Project	IEEE 802.16 Broadband Wireless Access Working Group < http://ieee802.org/16 >	
Title	Handoff text clarifications and enhancements	
Date Submitted	2004-05-10	
Source(s)	Yigal Leiba Itzik Kitroser Yossi Segal Zion Hadad Runcom Technologies Ltd. 2 Hachoma St. 75655 Rishon Lezion, Israel	Voice: +972-3-9528440 Fax: +972-3-9528805 yigall@runcom.co.il itzikk@runcom.co.il yossis@runcom.co.il zionh@runcom.co.il
Re:	Contribution on comments to IEEE P802.16e/D2	
Abstract	Contribution elaborating on HO process optimization	
Purpose	To be integrated into IEEE P802.16e/D2 document	
Notice	This document has been prepared to assist IEEE 802.16. It is offered as a basis for discussion and is not binding on the contributing individual(s) or organization(s). The material in this document is subject to change in form and content after further study. The contributor(s) reserve(s) the right to add, amend or withdraw material contained herein.

HO text clarifications and enhancements

Figure 1: HO process

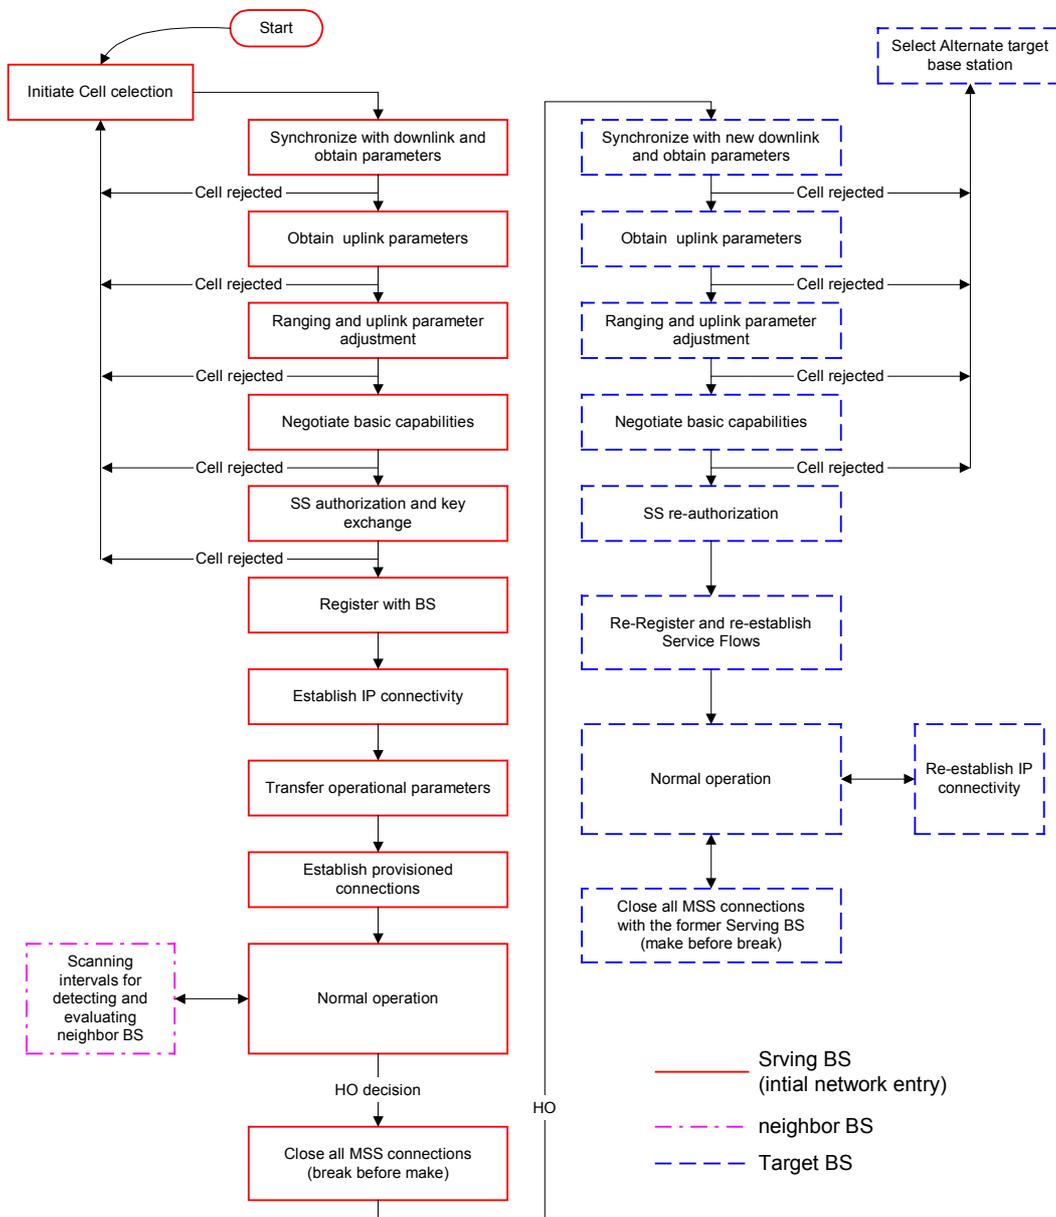
Figure 1 below depicts the current initial network entry and HO process. Several message exchanges having to do with HO can be streamlined or postponed in order to speed-up the HO process.

1. RNG-REQ/RSP exchange – A Non-contention RNG-REQ/RSP (otherwise known as ‘invited ranging’) should be by the target BS. This should be possible by using the timing estimation fields in the HO messages. One RNG-REQ/RSP exchange should suffice, because the SS has most of the information required to send the RNG-REQ message with nearly correct parameters (i.e. timing and power).

2. SBC-REQ/RSP exchange – This exchange can be postponed until after the MSS completes the HO process and settles back in Normal mode. In the meanwhile the BS and MSS will only communicate using mandatory features of the standard.

3. PKM-REQ/RSP exchange – This exchange could be skipped if we do pre-authentication before HO, via the backbone. In such case, the MSS and the target BS will share a secret, that can be used after HO to derive a TEK, such that PKM can continue its operation seamlessly.

4. BW allocation for the MSS for message exchanges – It may be worthwhile to add text describing what is expected of the BS during the HO process in terms of allocating UL BW for the MSS for speedy HO.
